Reference: MDL000972

10 March 2021

RE: 3Ms of Cambridge GP Limited – Addendum to Application SP/0179/20

3MS DEVELOPMENT LAYOUT

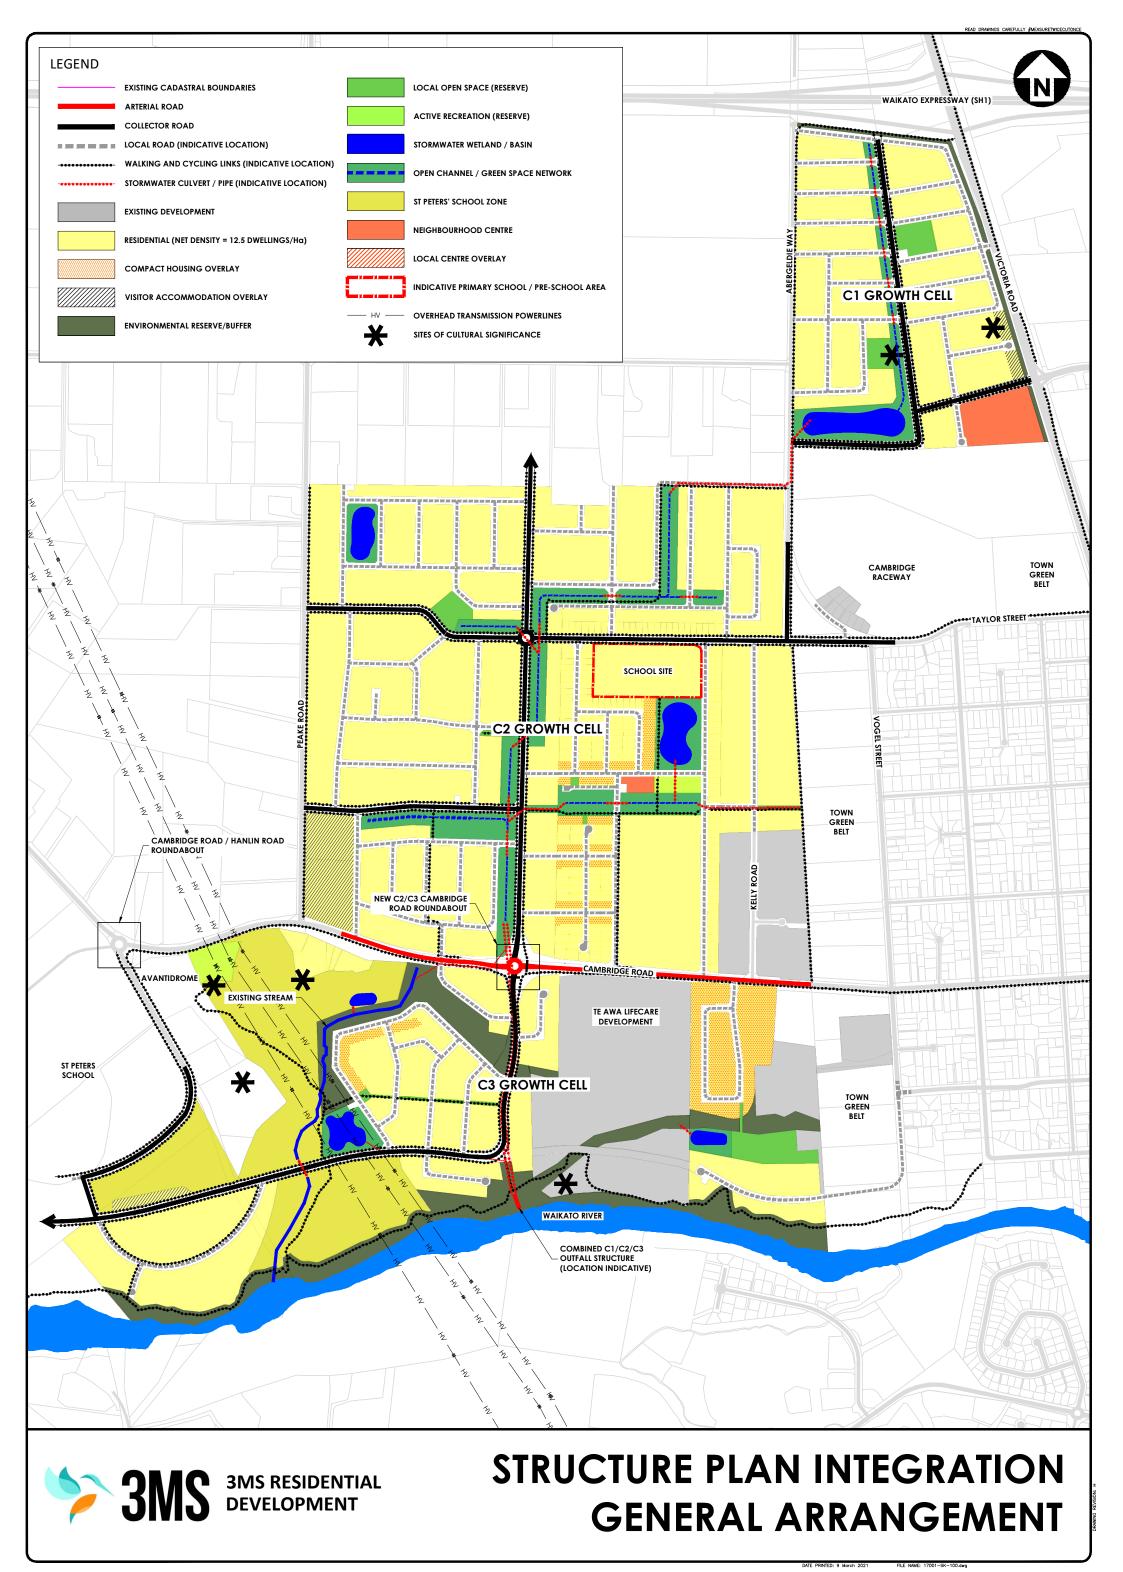
- (a) The eastern stormwater connection reserve will also encompass a road reserve (i.e. future local road link to Kelly Road by others):
- (b) The sizes of the lots on the eastern boundary have been adjusted to accommodate the above update.

- **3Ms Property Layout Alternative Development** 17001-SK-094-REVK replaces drawing 17001-SK-094-REVJ which is shown as Figure 1 and Figure 7 in the application.

DATE PRINTED: 9 March 2021 FILE NAME: 17001-SK-102.dwg

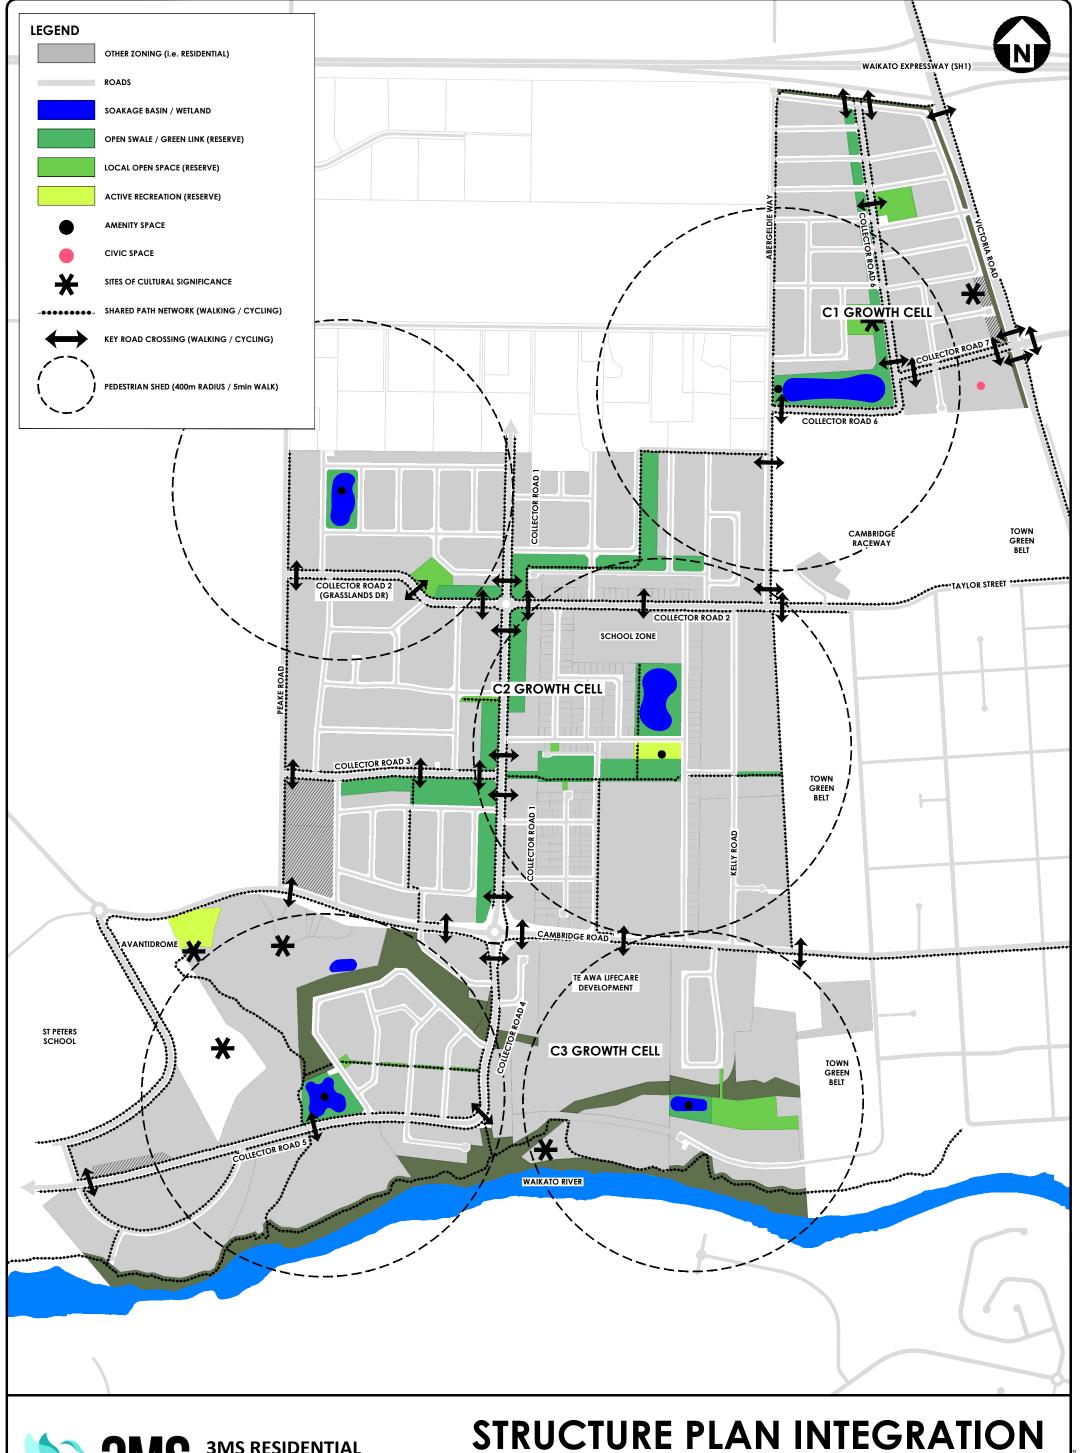
- Structure Plan Integration Stormwater Network 17001-SK-102-REVD replaces drawing 17001-SK-102-REVC in Appendix D of the application.
- > Structure Plan Integration Transport Network 17001-SK-103-REVD replaces drawing 17001-SK-103-REVC in Appendix D of the application (and Figure 15 in respect of the local road).

STRUCTURE PLAN INTEGRATION
WALKING & CYCLING

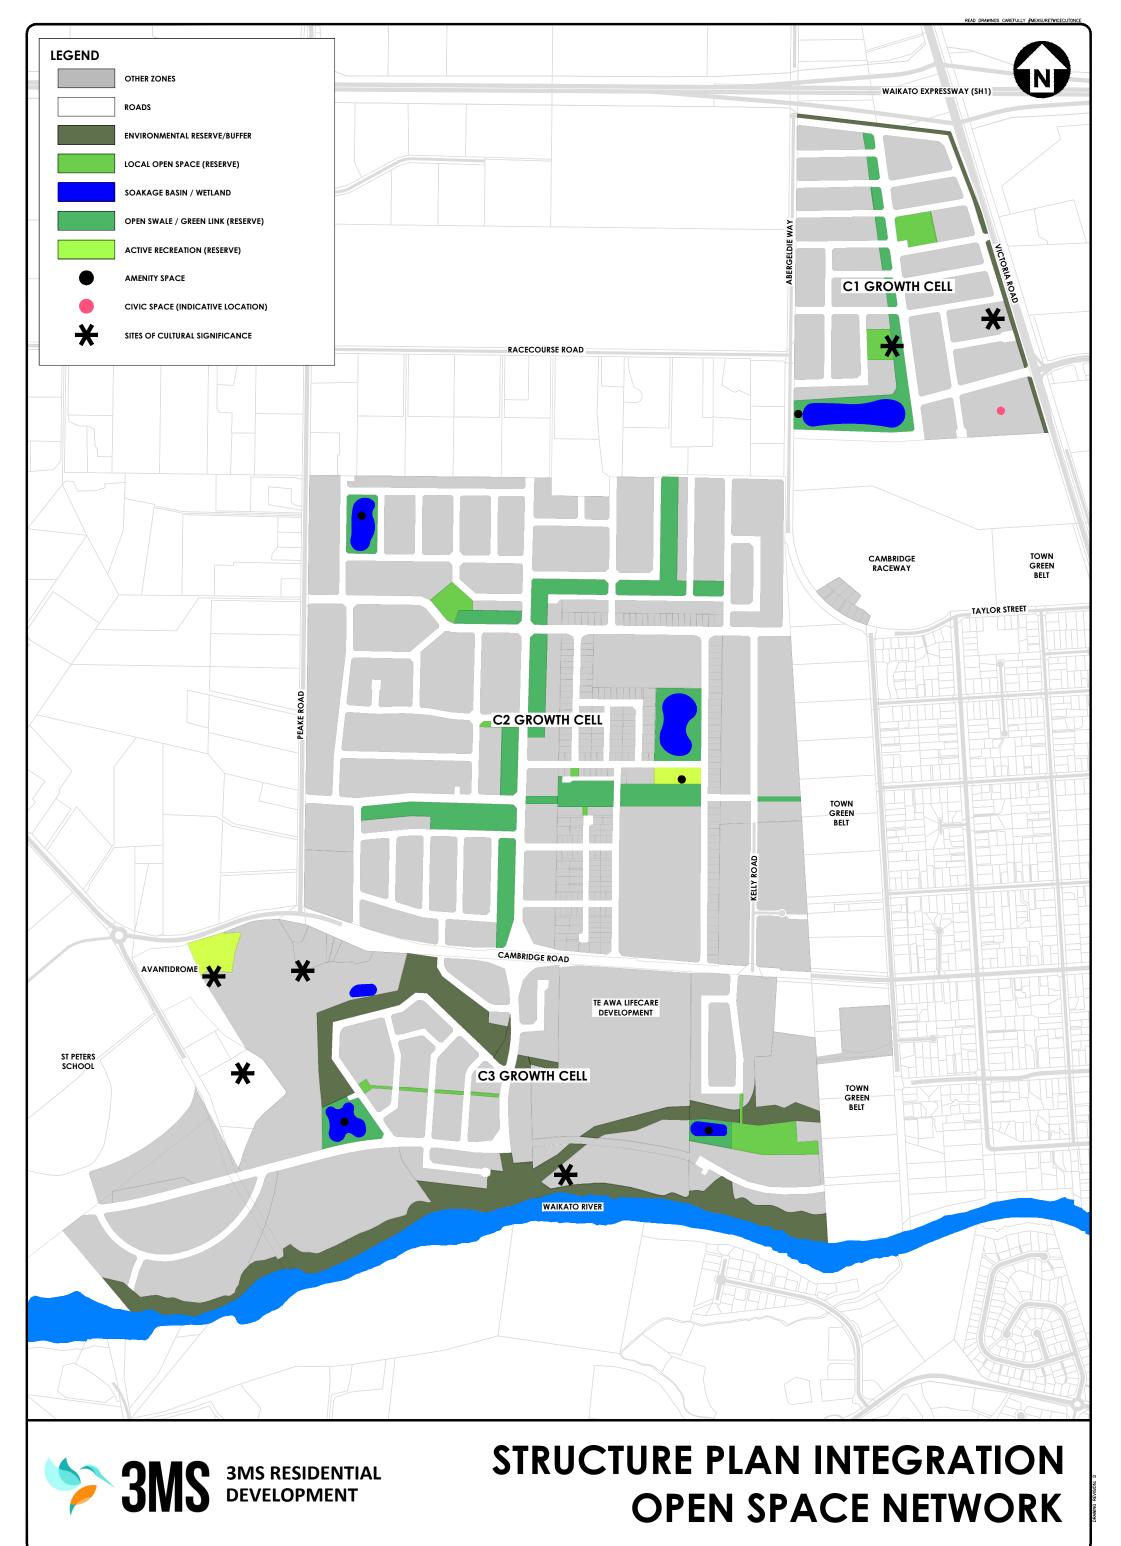
- Structure Plan Integration Walking & Cycling 17001-SK-104-REVD replaces drawing 17001-SK-104-REVC in Appendix D of the application (and Figure 16 of the application in respect of the local road).

DATE PRINTED: 9 March 2021 FILE NAME: 17001-SK-105.dw

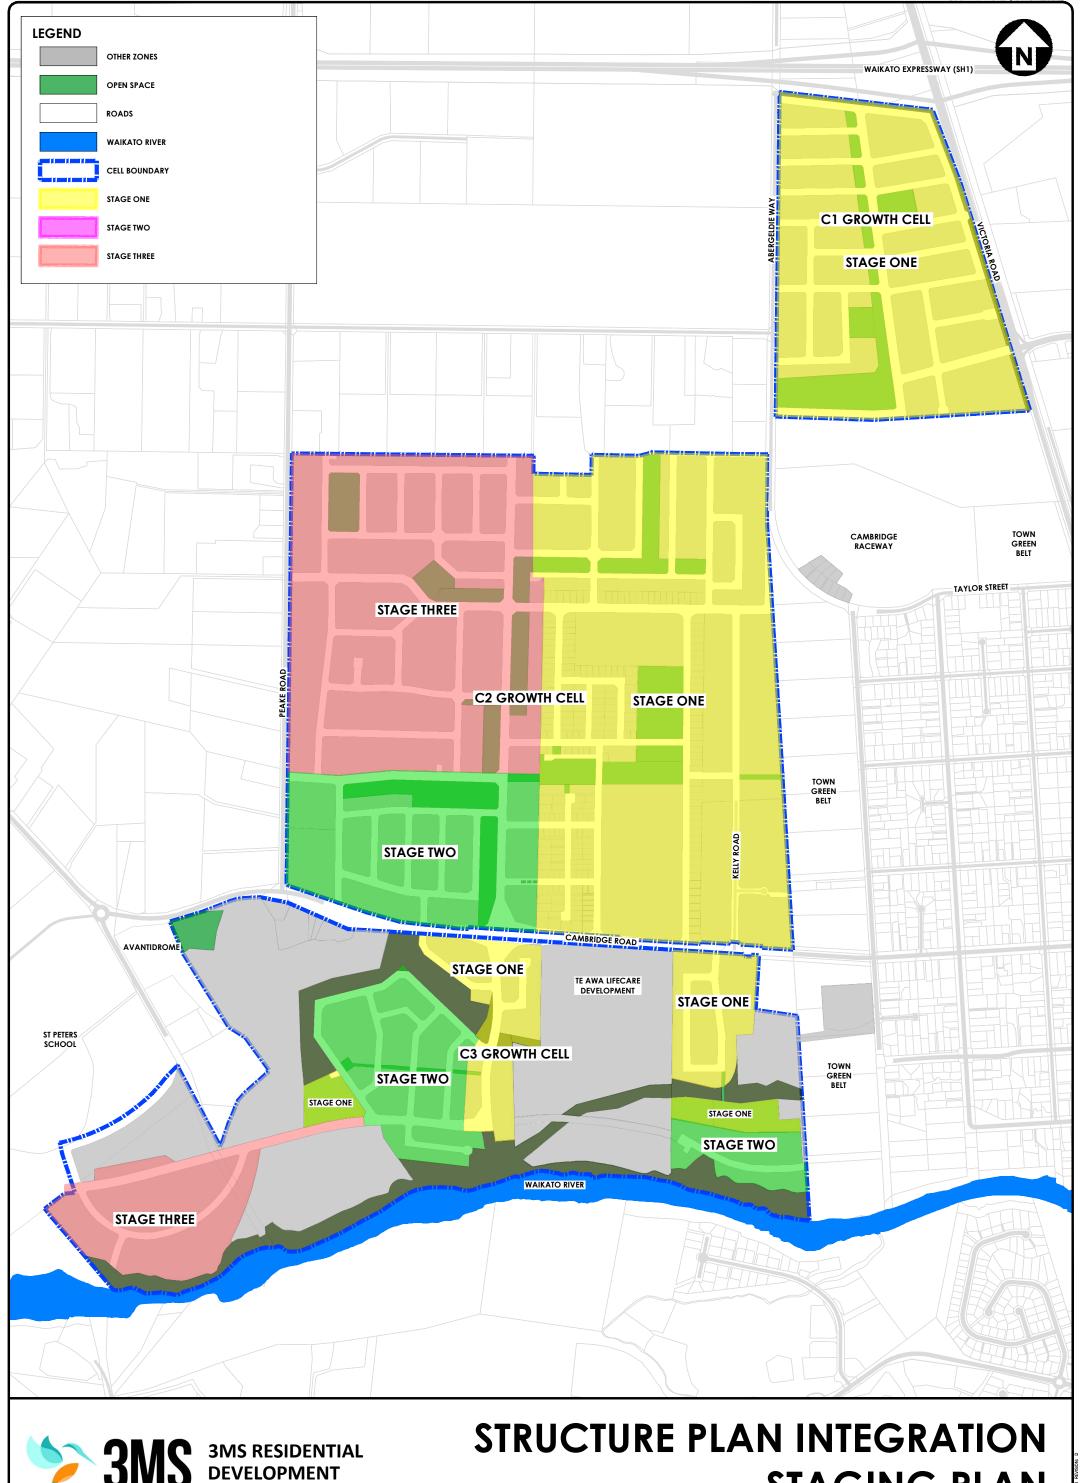
- > Structure Plan Integration Open Space Network 17001-SK-105-REVD replaces drawing 17001-SK-105-REVC in Appendix D of the application.
- Structure Plan Integration Staging Plan 17001-SK-106-REVD replaces drawing 17001-SK-106-REVC in Appendix D of the application.

WDC LAND ACQUISITION UPDATED 3MS LAYOUT

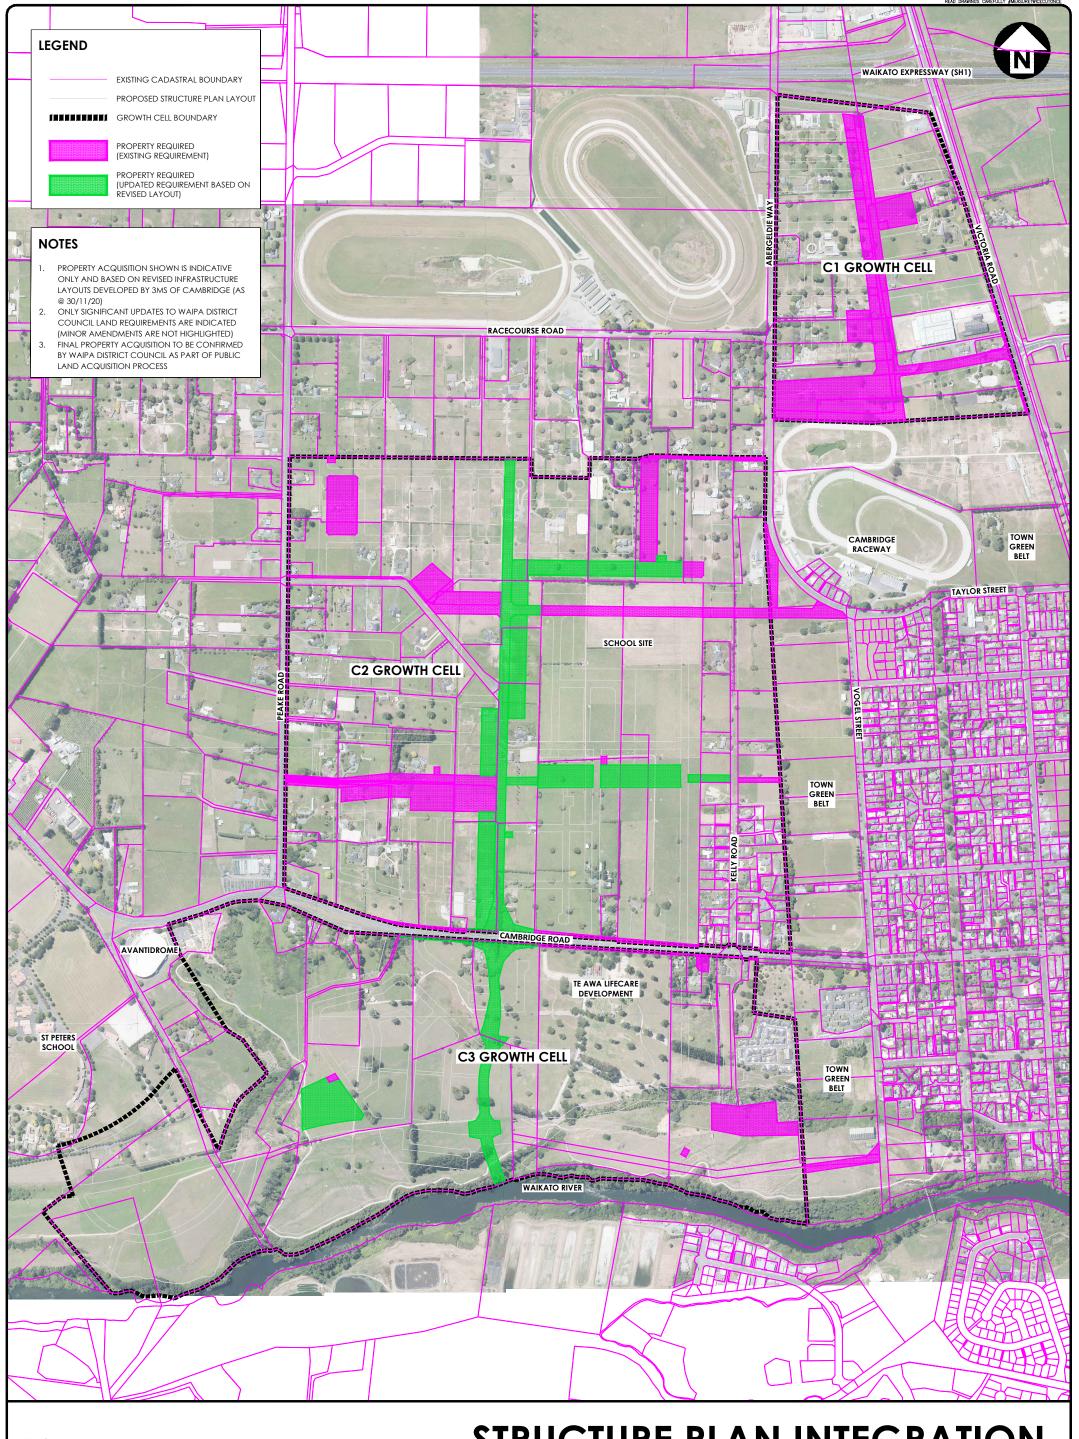
- **WDC Land Acquisition Updated 3Ms Layout** 17001-SK-117-REVC. A plan of this nature is not shown in the application currently.
- > Structure Plan Integration Revised Land Requirement Plan 17001-SK-109-REVB replaces drawing 17001-SK-109-REVA which is shown as Figure 43 in the application.
